Sketch File No. 16
Uvalde Coun
J. W. Cummings Sketches
& Report
Dated March 1876
Filed 193
J. H. Walker, Comr
File Clk
Descriptive:

County Surveyors Office - Uvalde County, Texas
At Uvalde March 1 - 1876

I herin enclose a more correct Plat, showing the true position of Surveys Nos. 318, 319 and 321, ^{on Turkey Creek} and relative position of other Surveys - including their connecting position with the Mueces River body of work. I have spent much time and labor in obtaining this, and can give my assurance that the allegations to the Plat by me may be relied upon - R. B. Hays, who made the first named Survey was at the time quite a young man, and possibly knew nothing about variation of the Needle & has probably had a plane Compass, without Vernier Plate, and run his lines to the Cardinal points of the Needle - at any rate, that is the way those lines are, nevertheless that his field Notes calls for variation

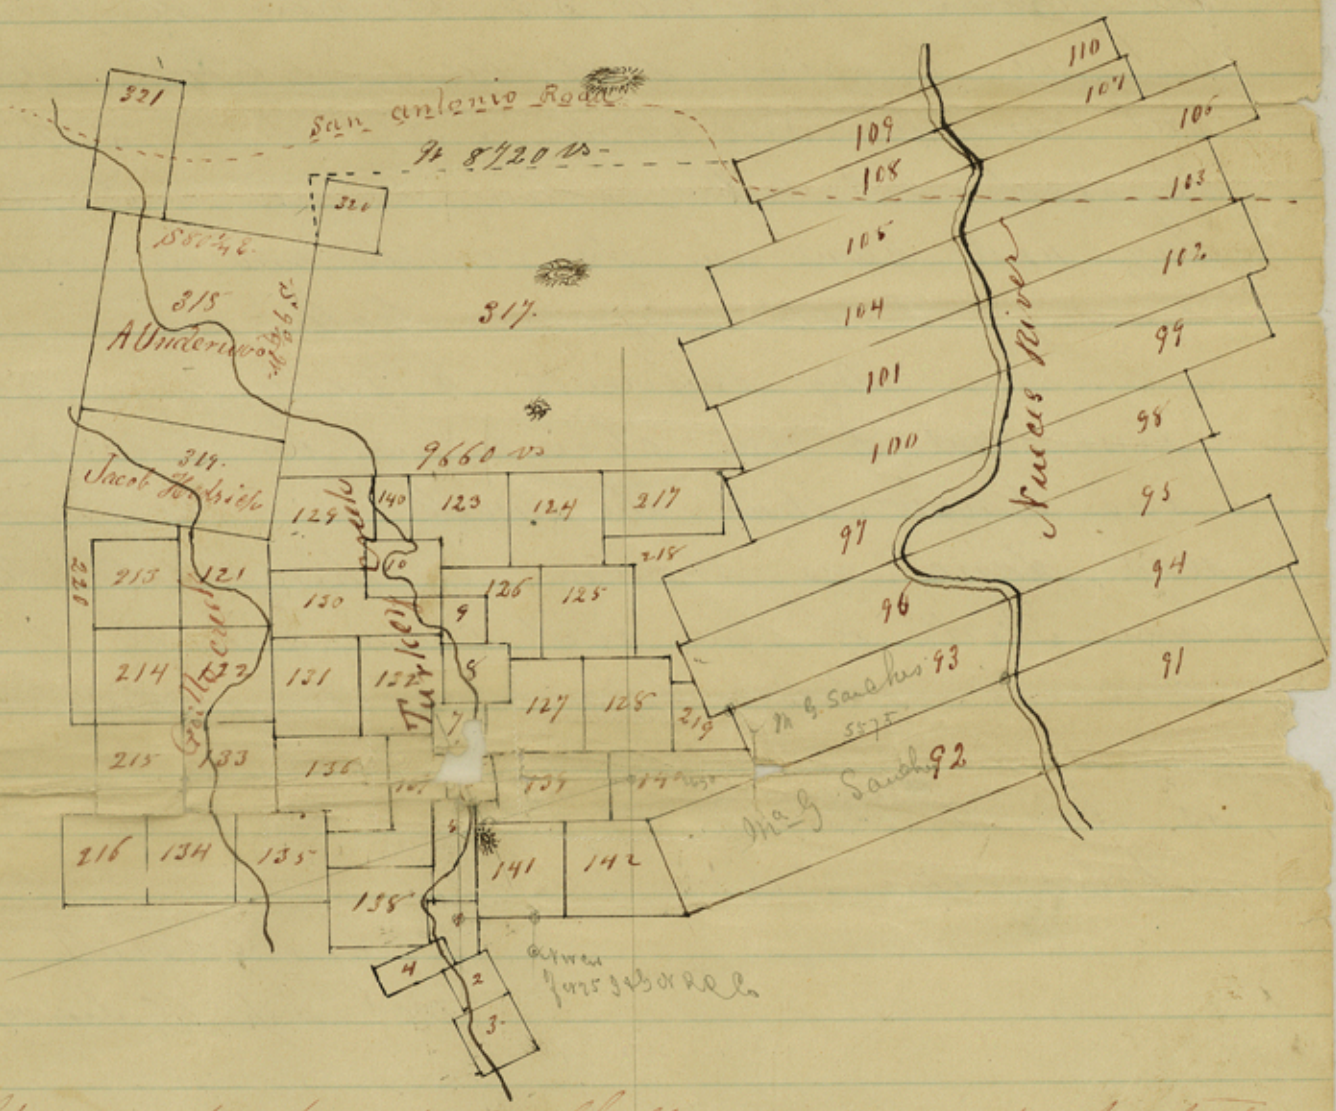
If the surveyor intends to controvert old surveys by a new survey it
is necessary for the surveyor to put his compass in the same variation
as the surveys are run, in this case $9^{\circ}45'$, and if he find the course
run on the ground different from the rule in the field notes, must
state the fact. The surveys 92 up to 109 are made by a varia-
tion of $9^{\circ}34'$ and are carefully surveyed, as the surveyor states
with in, but fails to state whether he found them in accord
with the field notes or not. The surveys 317 up to 322 are run
with the same variation and by a course N. E. S. W. all made
by the same surveyor and at the same time and can not be
expected that No. 322 is run by the magnetic line while the
surveyor states in the field notes by a variation of $9^{\circ}34'$.
The surveys 5 up to 10 are made by the same variation and
the same course, while the surveyor gives them on his
sketch a different course all together.

The explanation in the certificate is indefinite. Connections must
be given between established corners, and differences in

Livide Co. Sp. File #16
course and distances must be given as found on the
ground in a plain language, and by figures, without
running around the stump and not hitting the point.
June 14/76
Thielpaper
